#### Astronaut Office Crew Consensus Report Columbus and Alpha Magnetic Spectrometer (AMS) Payloads Neutral Buoyancy Laboratory (NBL) Development Test

#### **Executive Summary**

This test was conducted on November 12 through 15, 2002, using the following Astronaut Office crew test participants: Clayton C. Anderson, Timothy J. Creamer, Michael L. Gernhardt, Claude Nicollier, Carlos I. Noriega (12A.1 piggy-back evaluation only), and Rex J. Walheim.

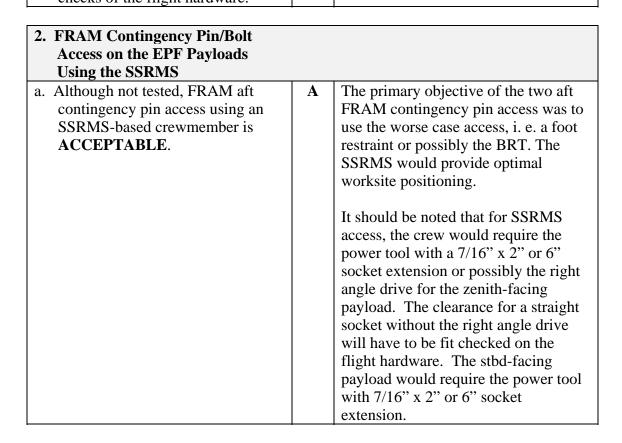
b. Stbd-facing payload installation or	1 <b>A</b>	Option 1 assumed a crew body		
the EPF is <b>ACCEPTABLE</b> using		positioning where the crew member is		
Option 1.		above the payload in a horizontal		
		orientation, with the body parallel to		
		the zenith side of the payload, head		
		towards port and feet towards stbd.		
	l l	to alab poli alla loot to malab biod.
